ADDENDUM NO. 1

PROJECT NAME: Life Sciences Annex – North and East Wing Renovations
UNL PROJECT NUMBER: A090P025 & A090P026

DATE OF ISSUANCE: February 6, 2012
DATE OF BID OPENING: Tuesday February 14, 2012 @ 2:00 p.m. CDT

Exterior Elevations

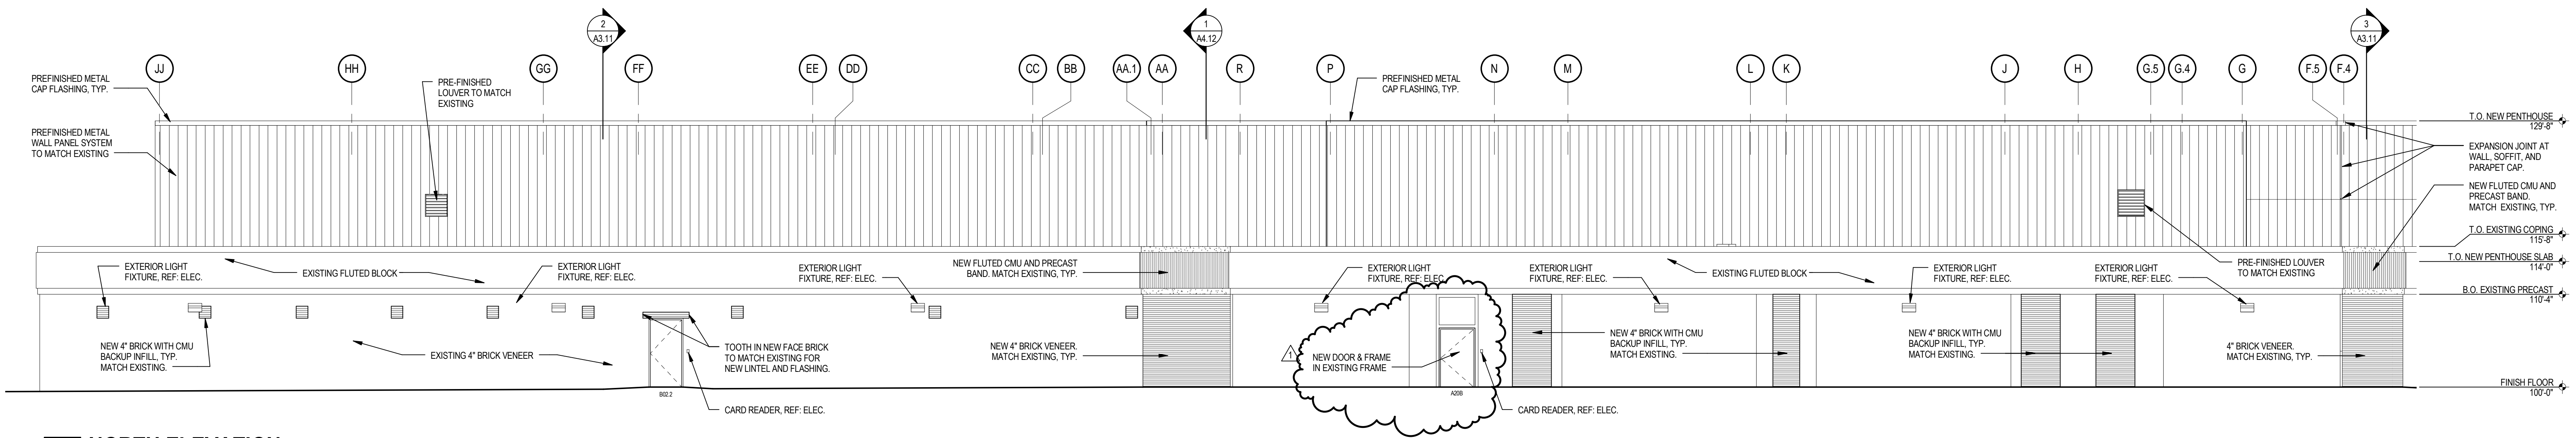
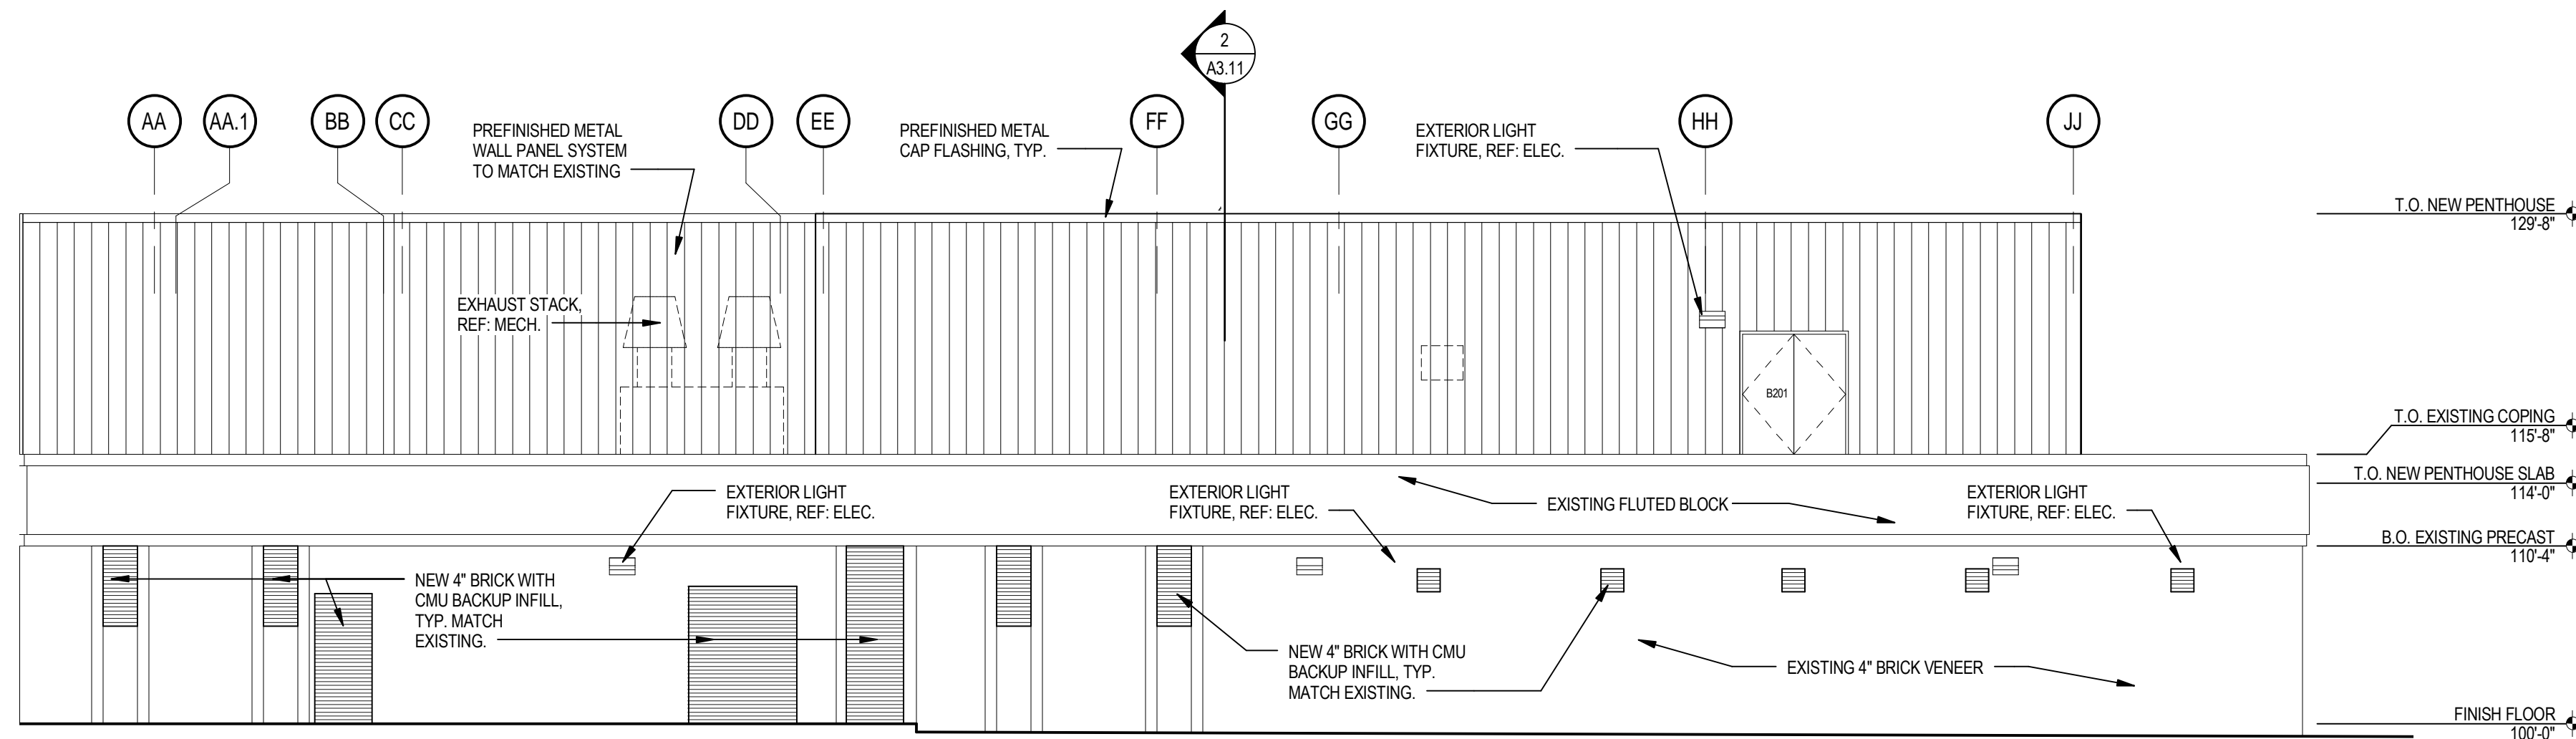
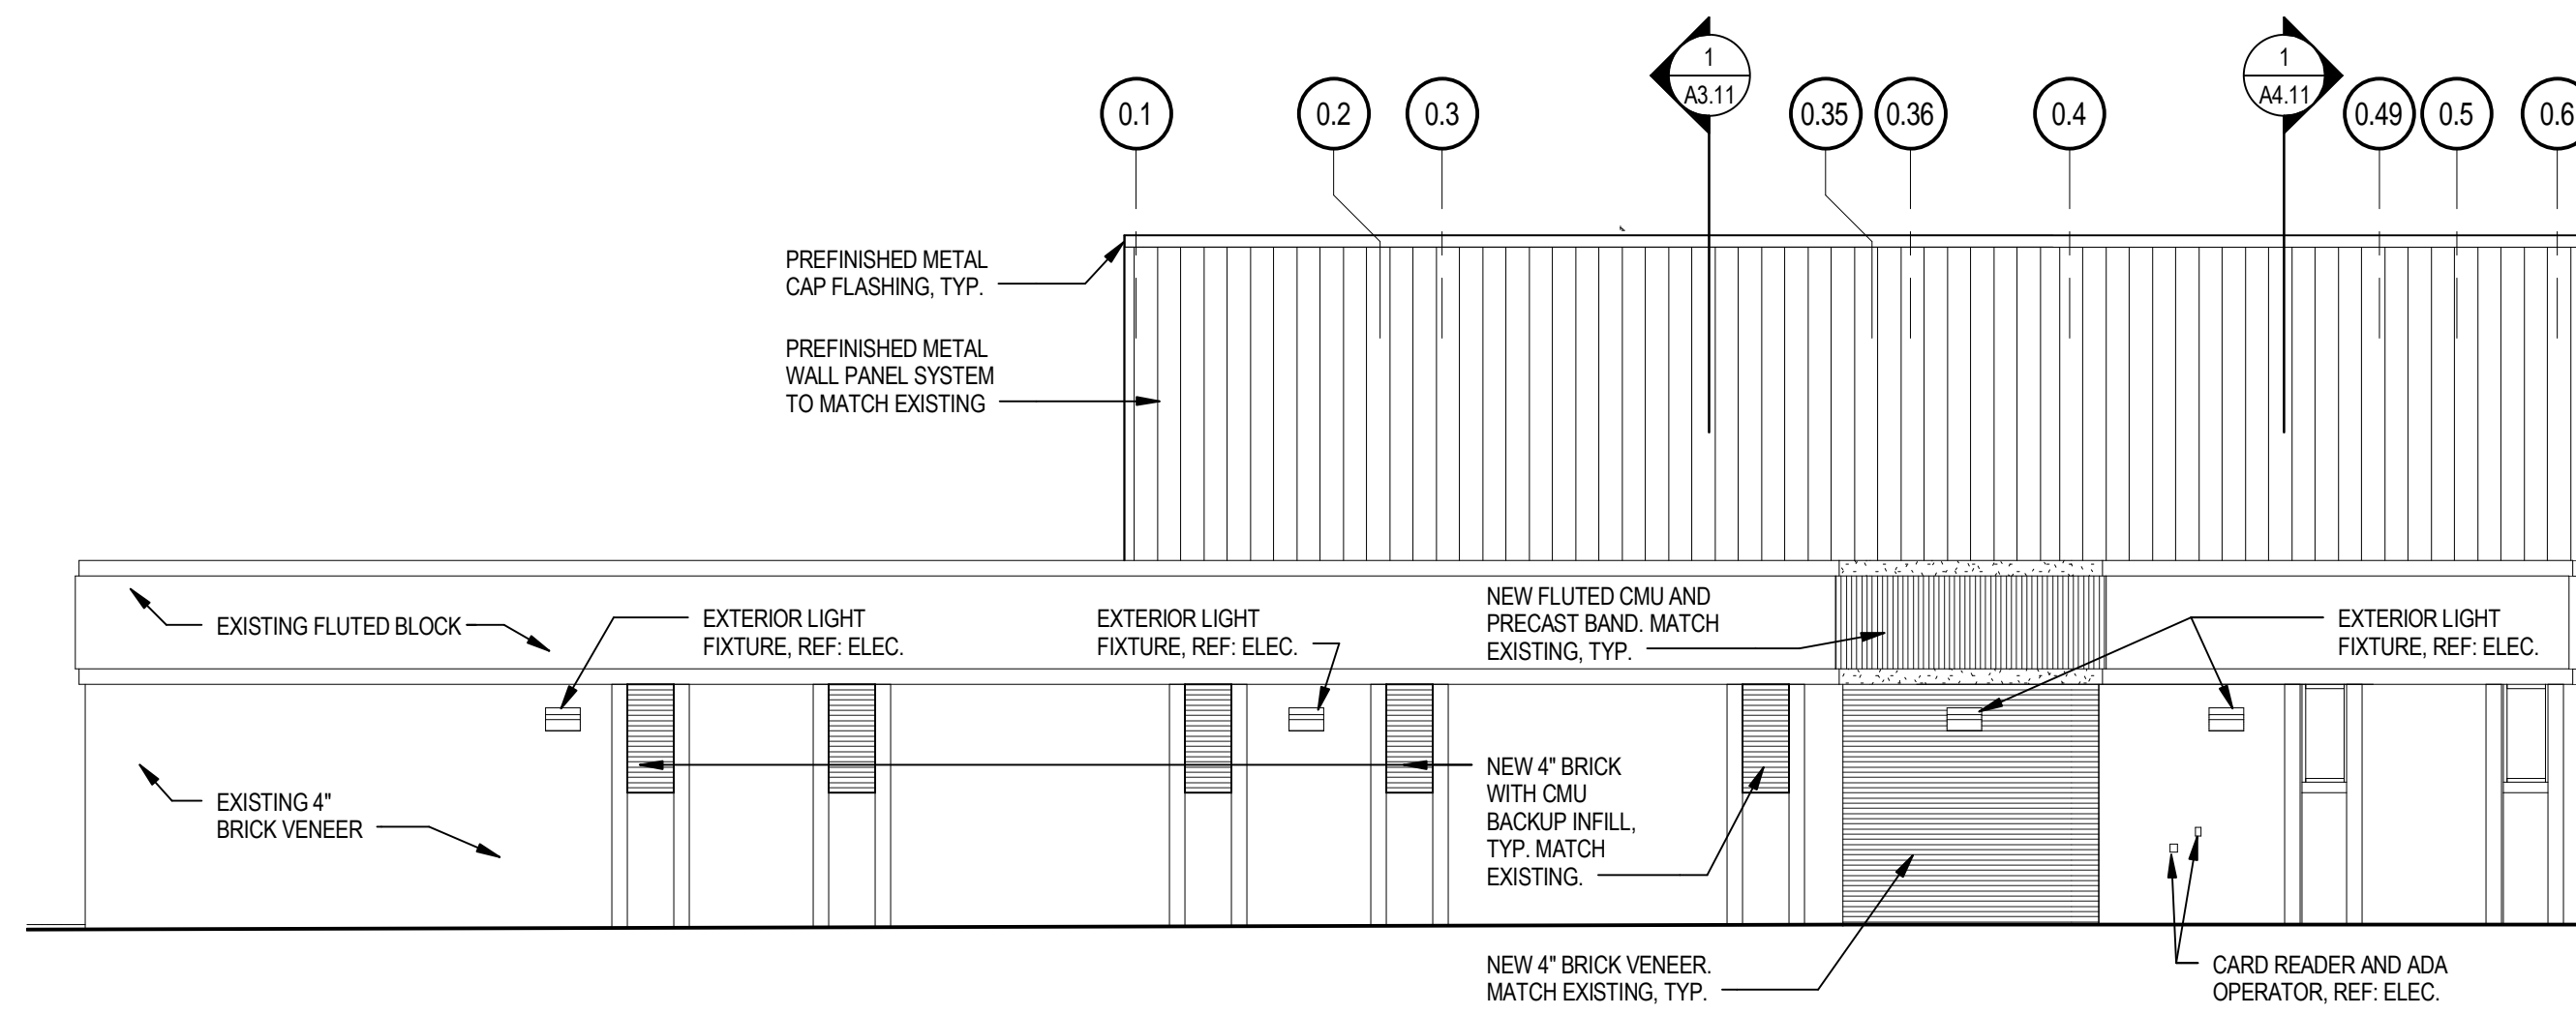
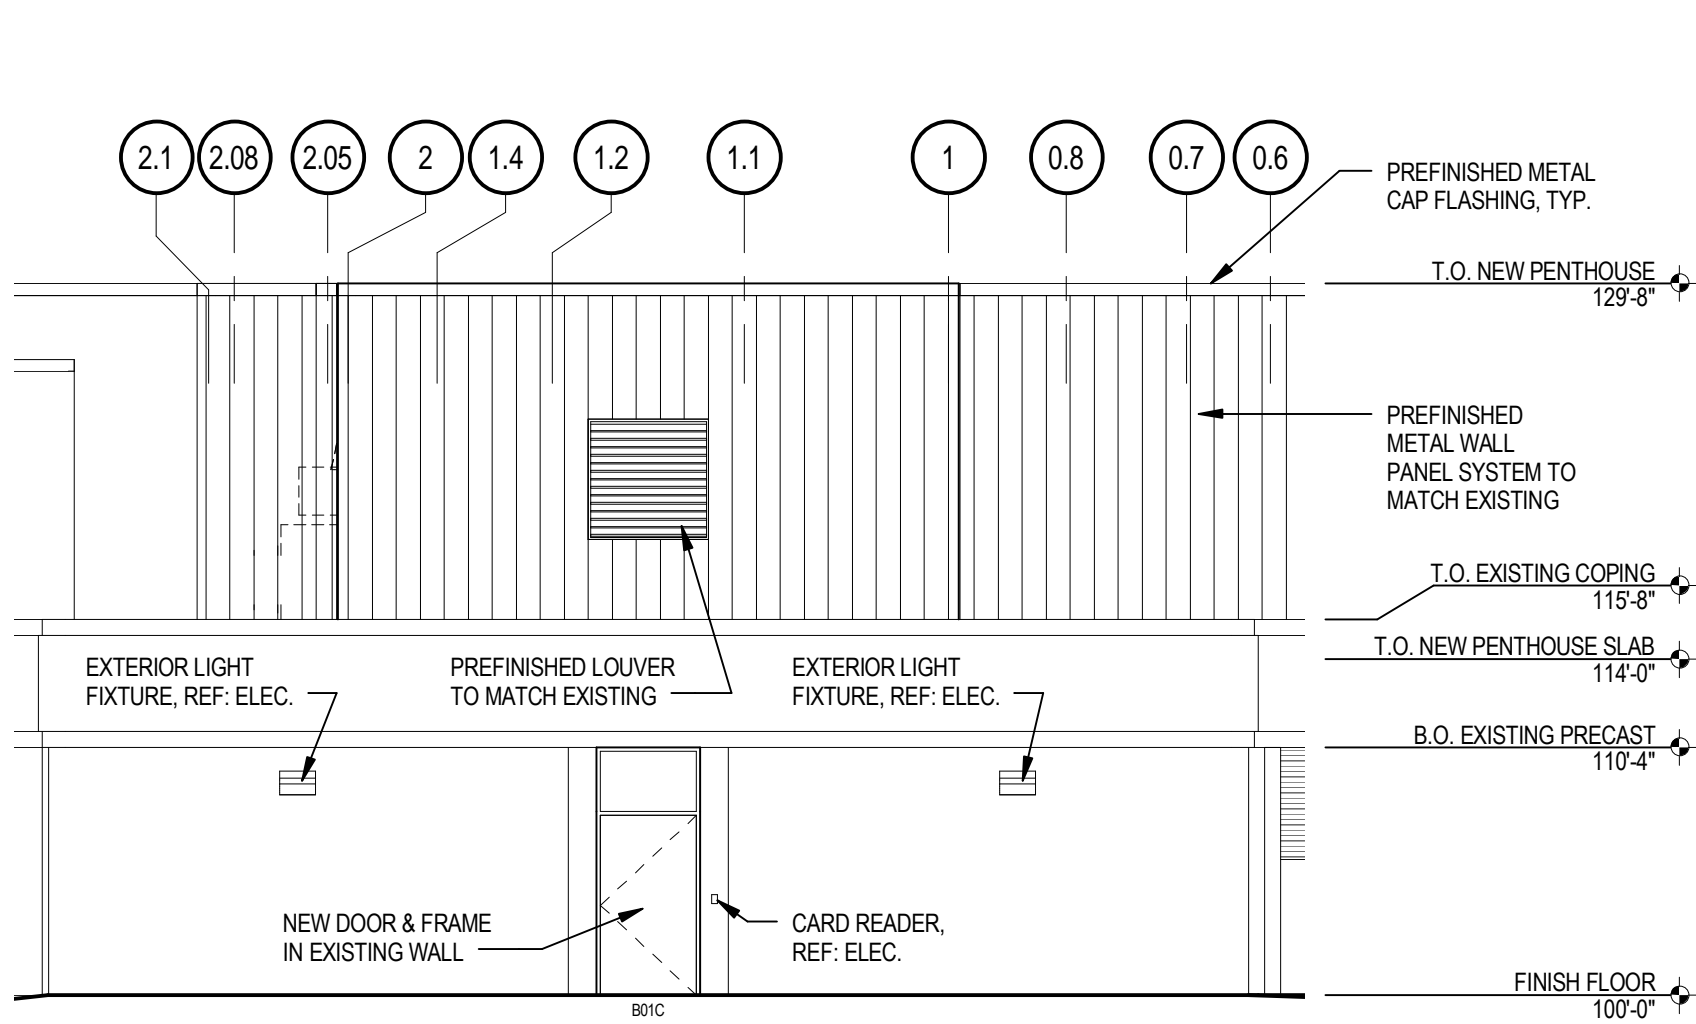
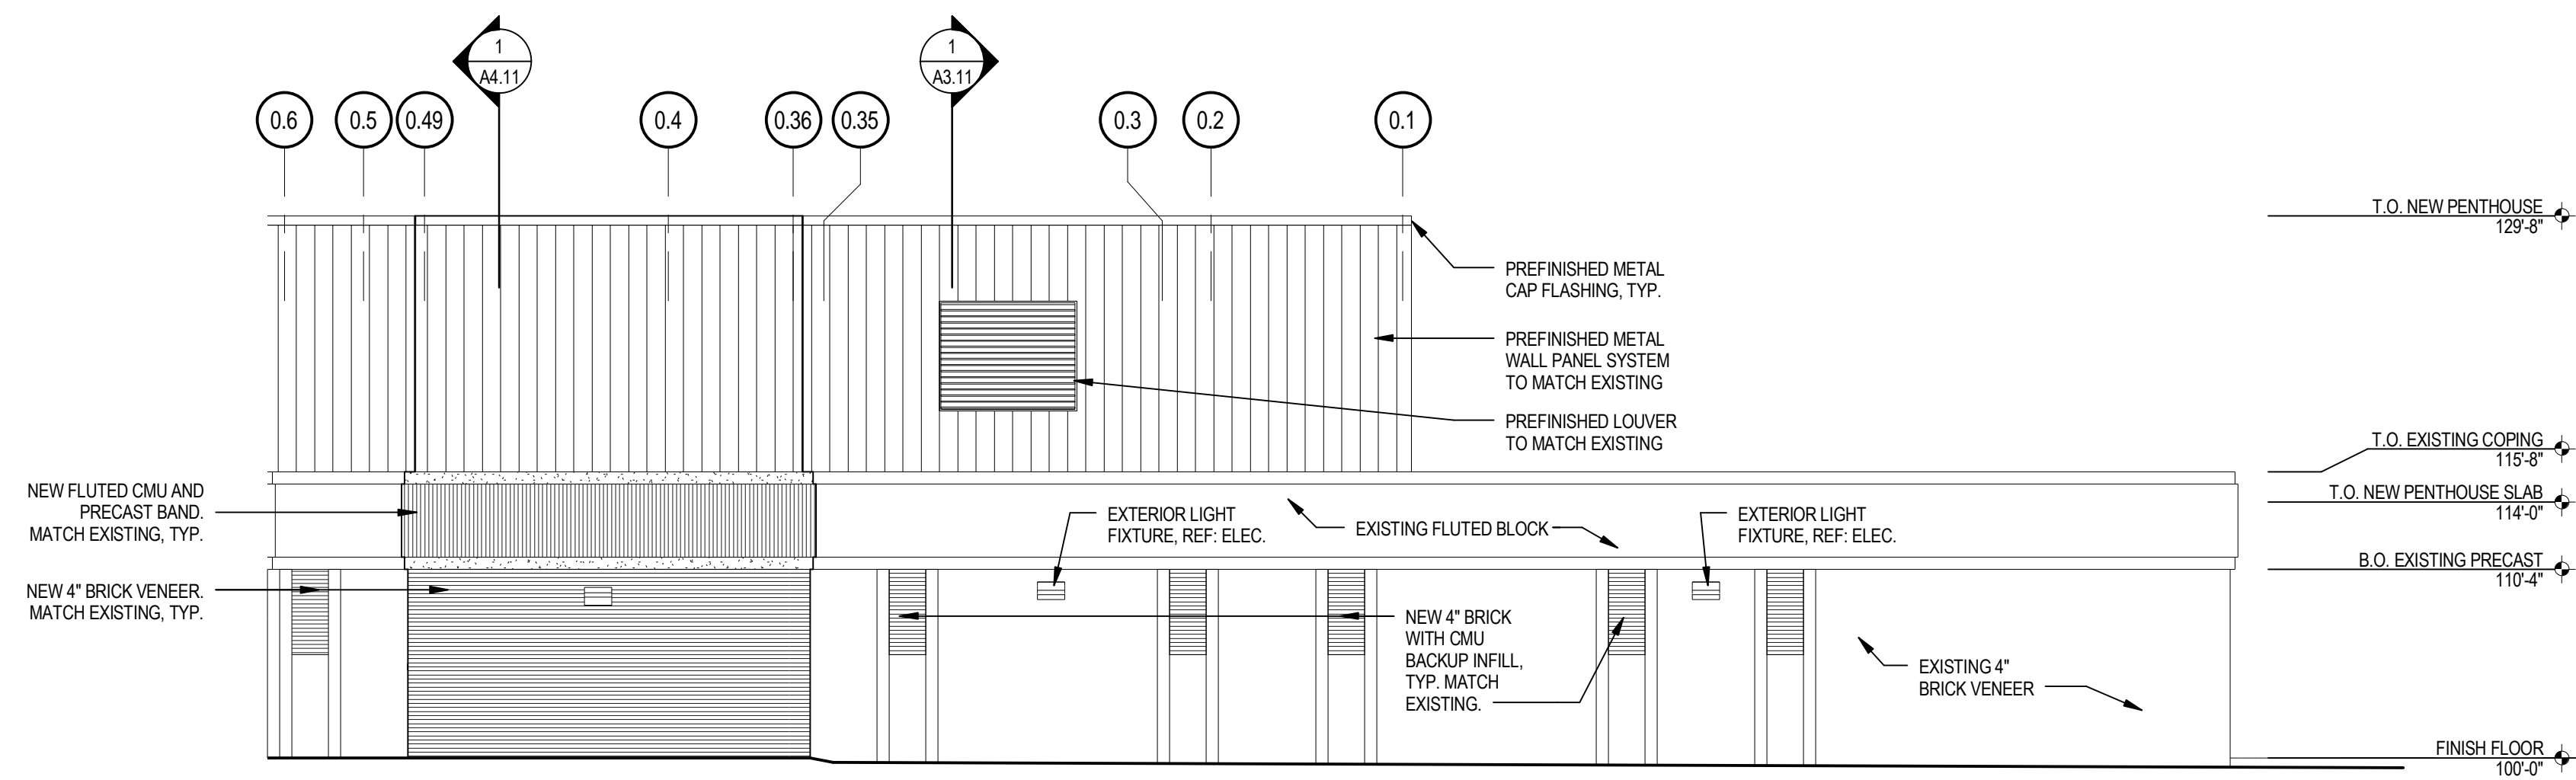
Sheet A2.11 has been updated. See attached reissued sheet with changes indicated.
